**STAFF RECOMMENDATION**

**1021 Paris Avenue**

**October 19, 2016**

**Application:** New construction—addition to outbuilding; Setback determination

Figure 1. 1021 Paris Avenue.

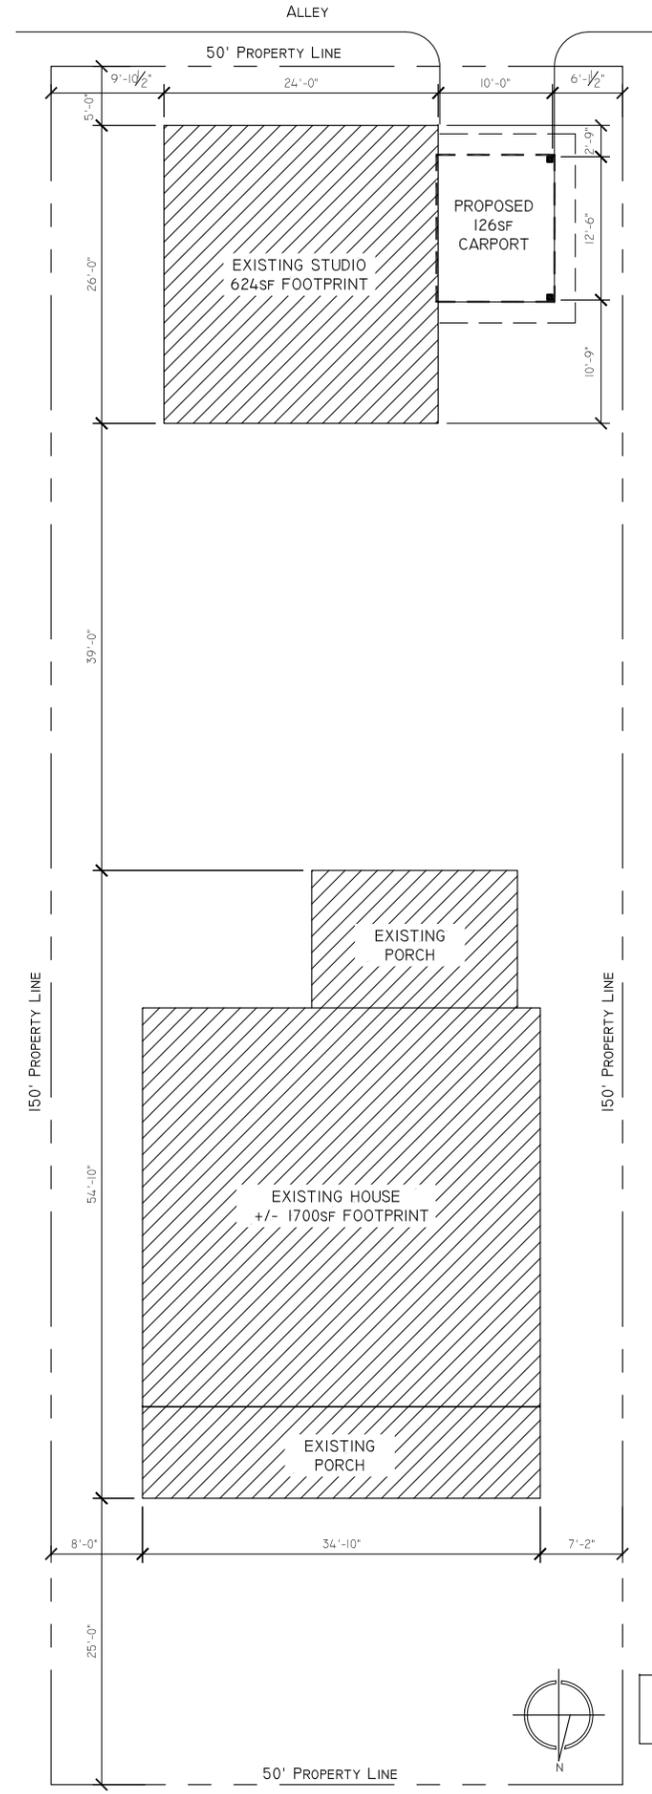
**Background:** 1021 Paris Avenue is a c. 1910 frame bungalow that contributes to the historic character of the Waverly-Belmont Neighborhood Conservation Zoning Overlay (Figure 1). In July 2016, MHZC staff issued an administrative permit to construct a six hundred and twenty-four square foot (624 sq. ft.) outbuilding. The outbuilding does not contain a garage and does not include a dwelling unit.

**1 SITE PLAN**  
 SCALE: 1/16"=1'-0"

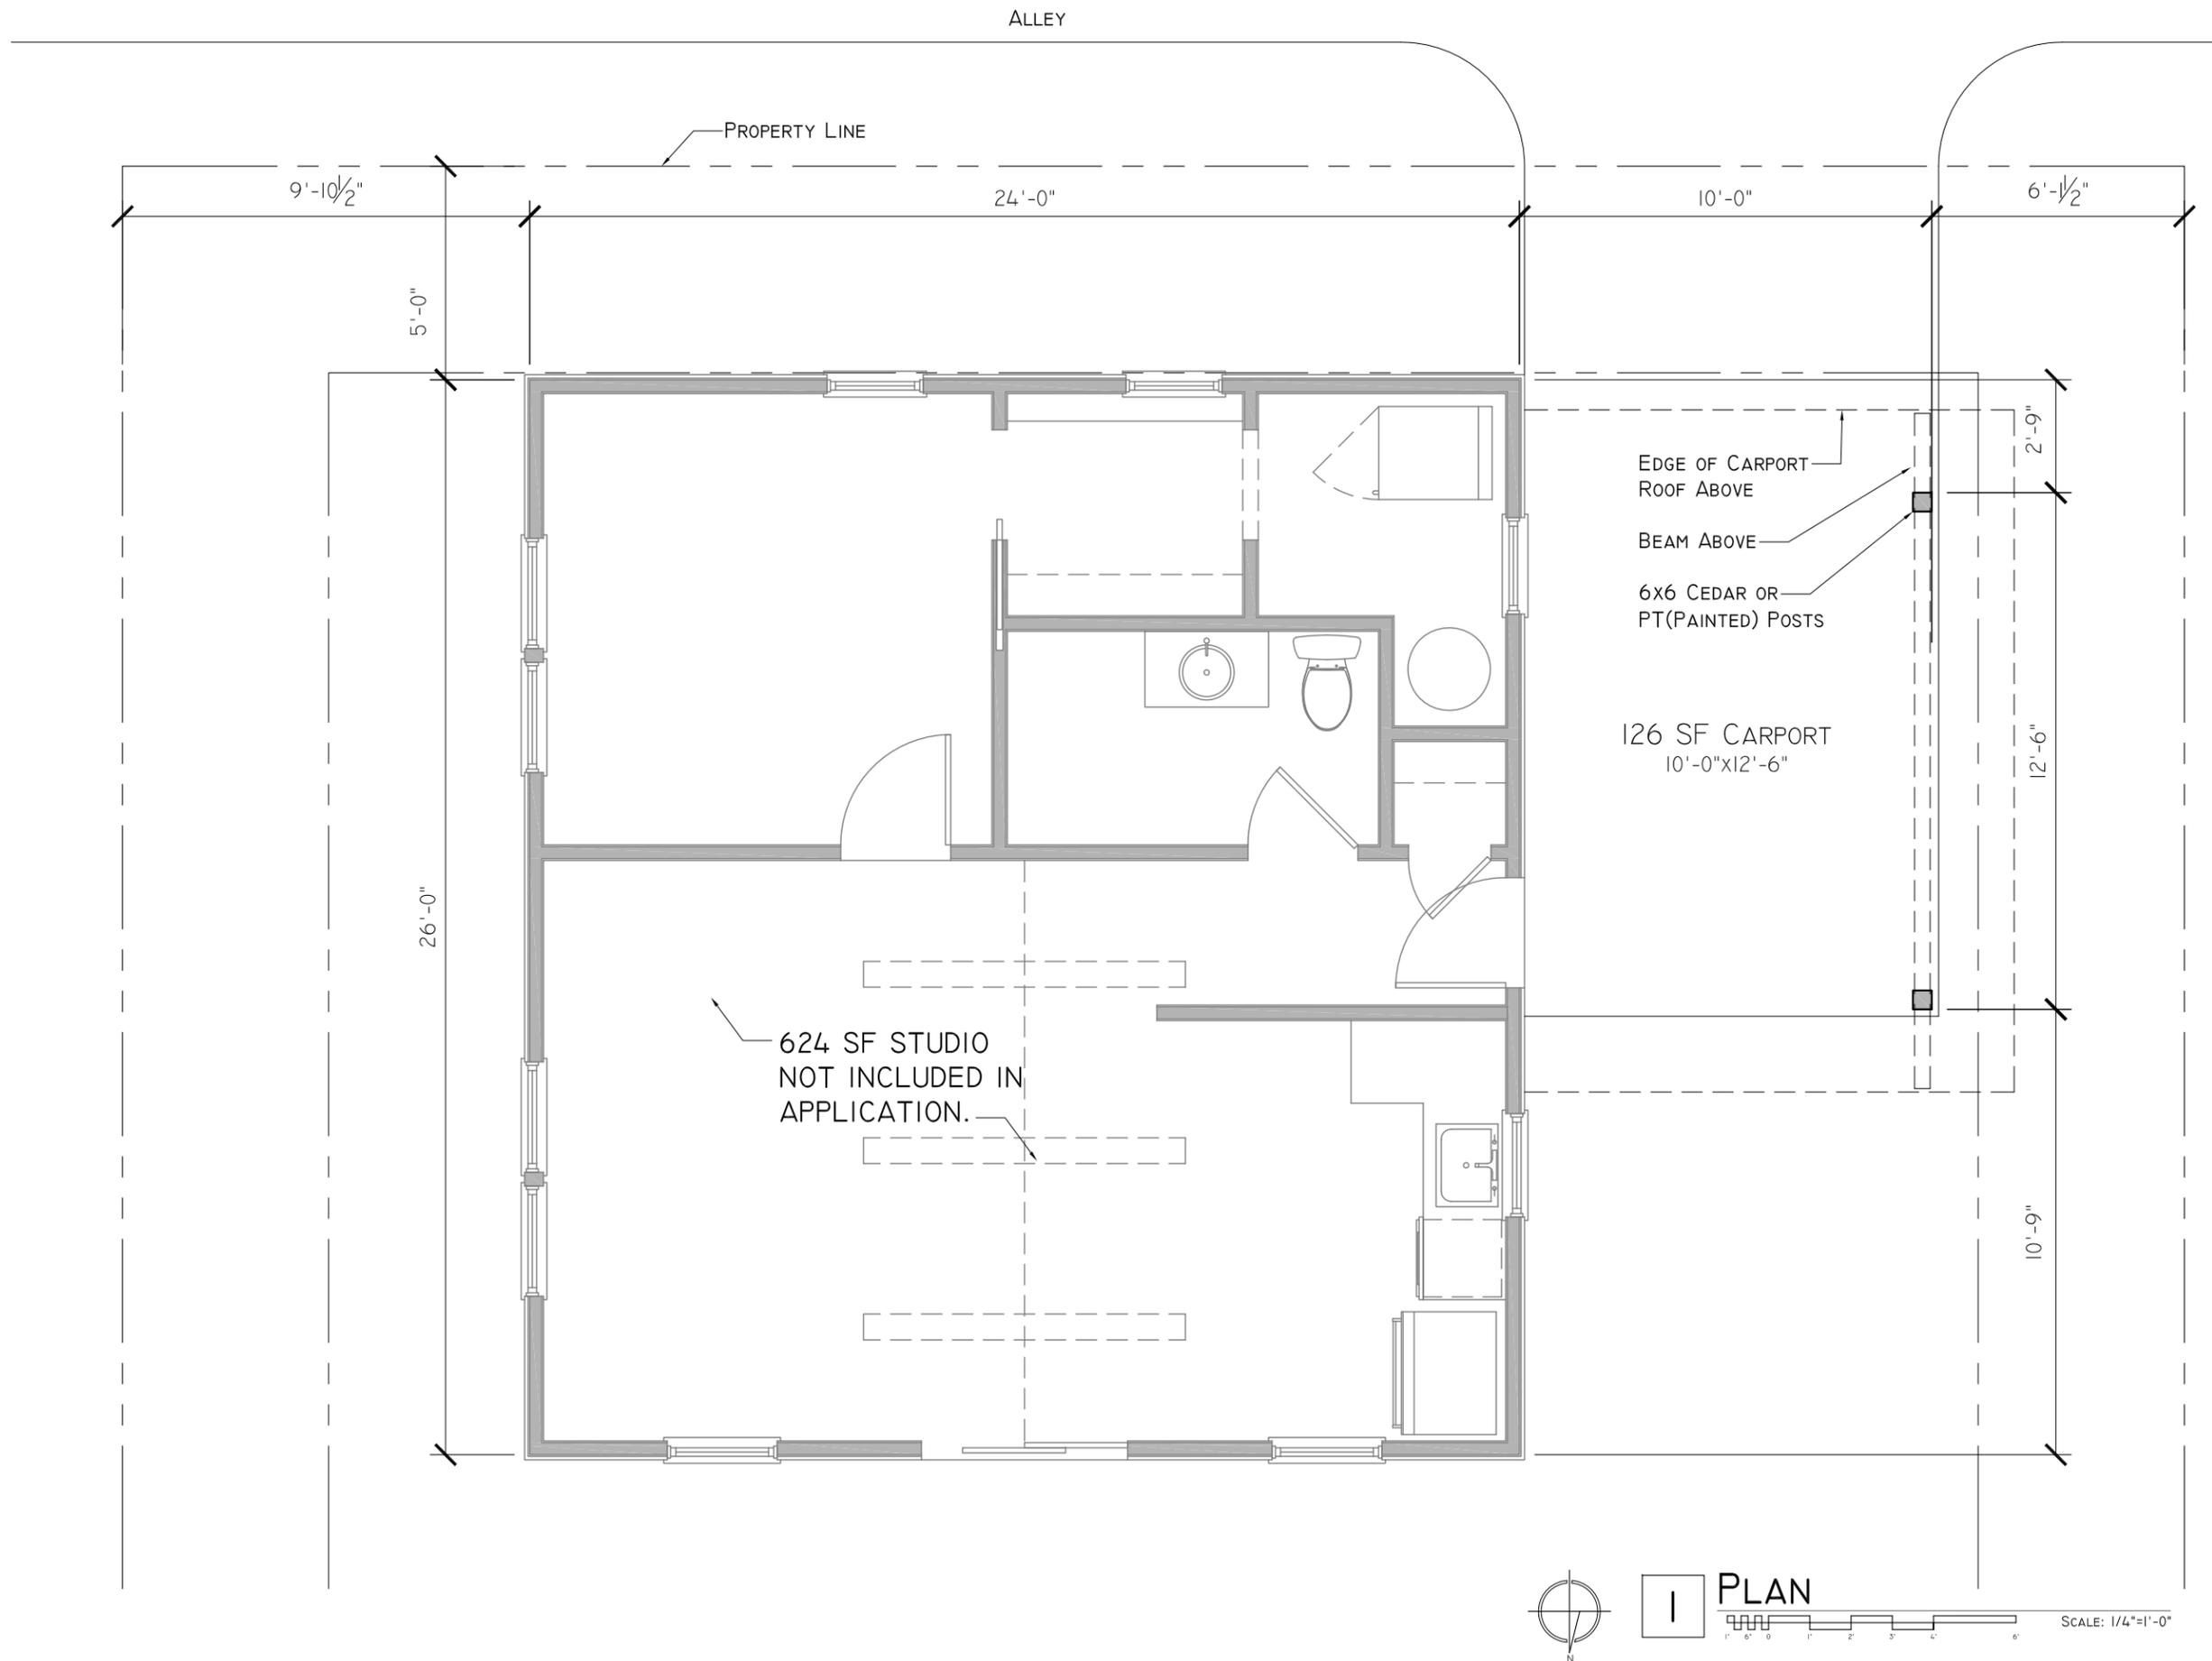
The carport addition to the outbuilding requires a rear setback determination. When an outbuilding has a footprint greater than seven hundred square feet (700 sq. ft.), base zoning requires that the structure be located twenty feet (20') from the rear property line and five feet (5') from the side property lines. In this instance, the structure is located at least five feet (5') from the side property lines, but it is located just five feet (5') from the rear property line. Staff finds that the proposed rear setback is appropriate because for structures that are seven hundred square feet (700 sq. ft.) or less that do not have vehicular doors, the rear setback is just three feet (3'). The previously approved outbuilding is located five feet (5') from the rear property line, and when it was approved, it met the rear base zoning setback. However, because the carport addition will increase the footprint of the overall structure to over seven hundred square feet (700 sq.ft.), the base zoning rear setback requirement increases to twenty feet (20').

The carport addition will not be any closer to the rear property line than the previously approved outbuilding. A five foot (5') rear setback for a structure that is slightly larger at seven hundred and fifty square feet (750 sq. ft.) is appropriate. Historically, outbuildings were located at the rear of the property, close to the rear property line. A five foot (5') rear setback is more historically appropriate than a twenty foot (20') rear setback. In addition, the five foot (5') rear setback allows for more space between the primary structure and the outbuilding. Staff recommends approval of the setback determination.
